SUNDRY NOTICES AND REPORTS ON WELLS

8. Well Name and No.
BANK 18 FEDERAL COM. 1H

OXY USA Inc. respectfully requests approval for the following changes to the drilling plan:

PECOS DISTRICT
CONDITIONS OF APPROVAL

Plan: Plan #2 (Bank 18 Fed #1H/1)
Created By: Patrick Rudolph
Date: 6/28/2013

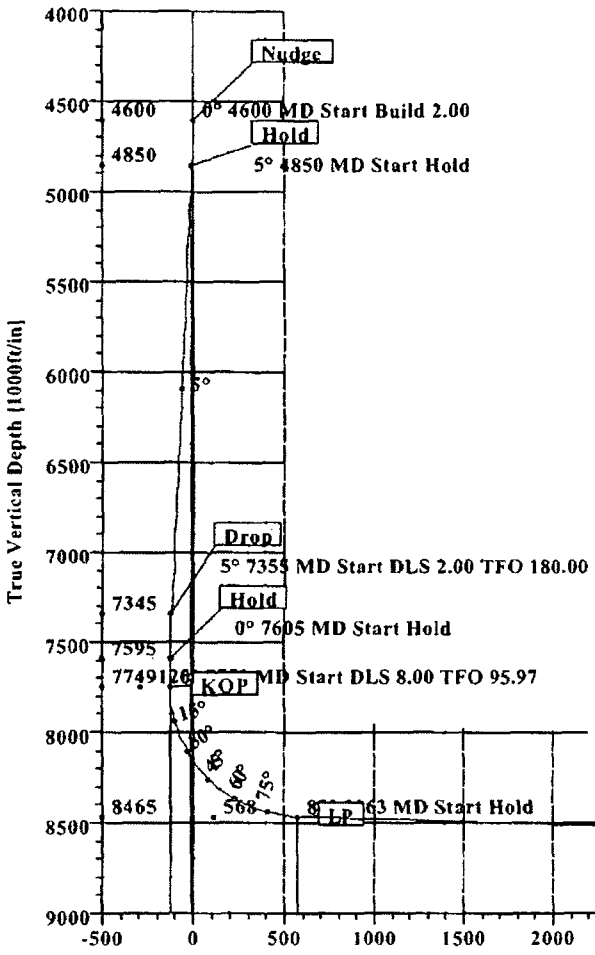
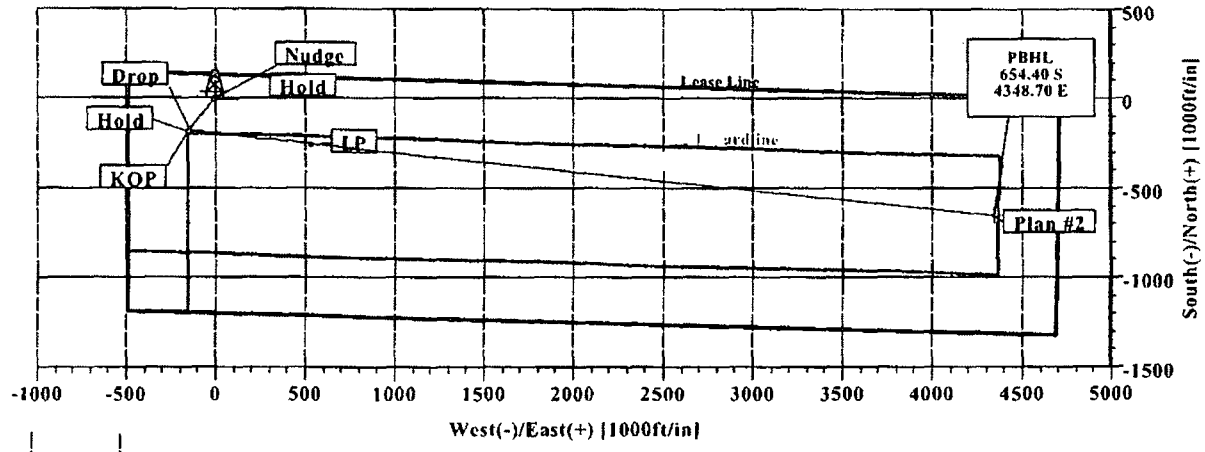
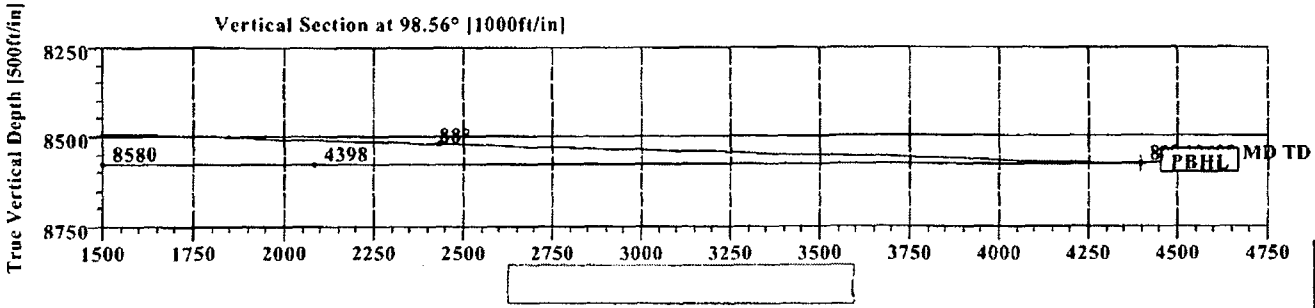
1. Change the Target formation from the Delaware-Brushy Canyon to the 2nd Bone Spring Sand. See attached for amended C-102 and new directional plan.

Projected TD - 12698'M 8580'V
Additional Formation Tops - Bone Spring 6250' - 1st Bone Spring 7110' - 2nd Bone Spring 7620' - 2nd Bone Spring Target 8465'
